Important Product Safety Bulletin First Notification

Eaton S801+ Series Reduced Voltage Soft Starter

S801+Series Non-functional Soft Starter

Figure 2 - Defective CIM

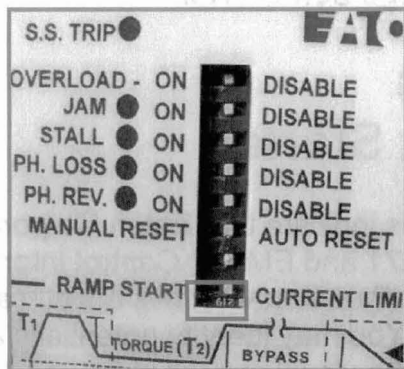
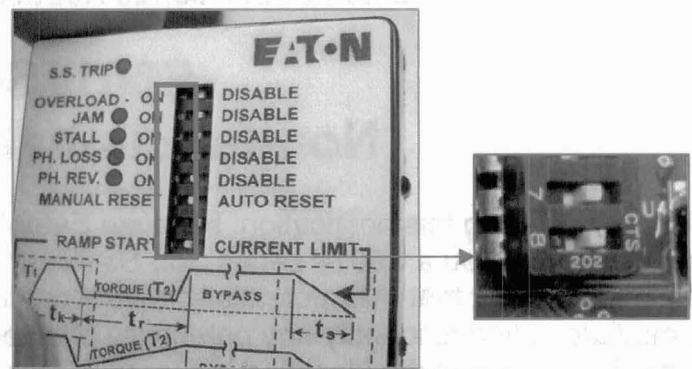
In affected units, the 8 position DIP switch may have been soldered in the incorrect position (upside down) on the CIM printed circuit board assembly. This may cause the selectable protection features and functionality defined on the CIM to be "ON" when the DIP switch is in the "DISABLE" position or "DISABLE" when in the "ON" position (DIP switch functionality reversed). This affects the following protection features and functionality: Overload, Jam, Stall, Phase Loss, Phase Reversal and Reset (manual vs. auto).

Once you have confirmed that this quality alert applies to your product, a defective CIM can be identified by performing a visual inspection of the DIP switch, highlighted in Figure 1 and Figure 2.

“219” MARKED UPSIDE DOWN ON THE BOTTOM OF THE DIP SWITCH

“202” MARKED RIGHT-SIDE-UP ON THE BOTTOM OF THE DIP SWITCH

Corrective Action – Units affected by this alert require a replacement of the CIM. This corrective action can be performed in the field if a defective CIM unit is identified. Please notify Eaton's Center of Return Excellence (CORE) at 800-410-2910, and a replacement CIM will be provided to you at no cost.

Figure 3 - Product's Date Code Label

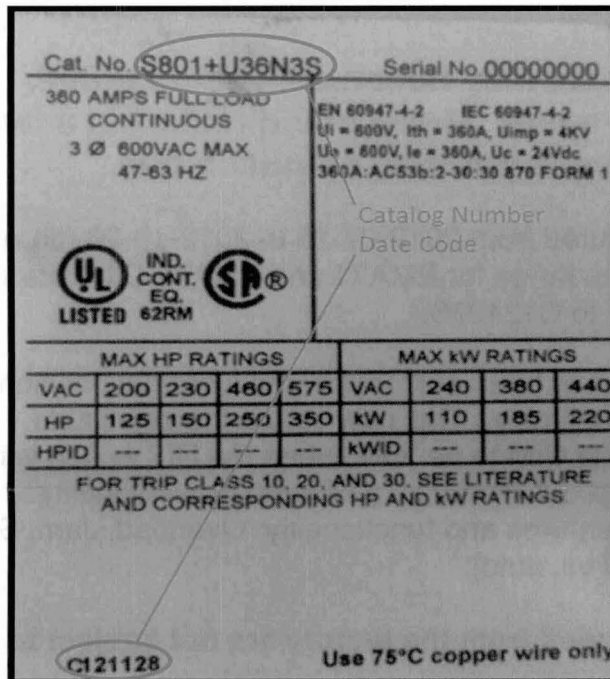
Affected unit identification is to be performed by visual inspection of the product catalog number and the date code. Please refer to Table 1 for affected catalog numbers and date code ranges. For S801+ Soft Starters, the date code is located on the product ratings label as shown in Figure 3. For CIMs sold as **kits** (EMA71 & EMA72), please locate the date code on the back of the CIM.

Date code format is a prefix C, followed by Year-Month-Date (YYMMDD).
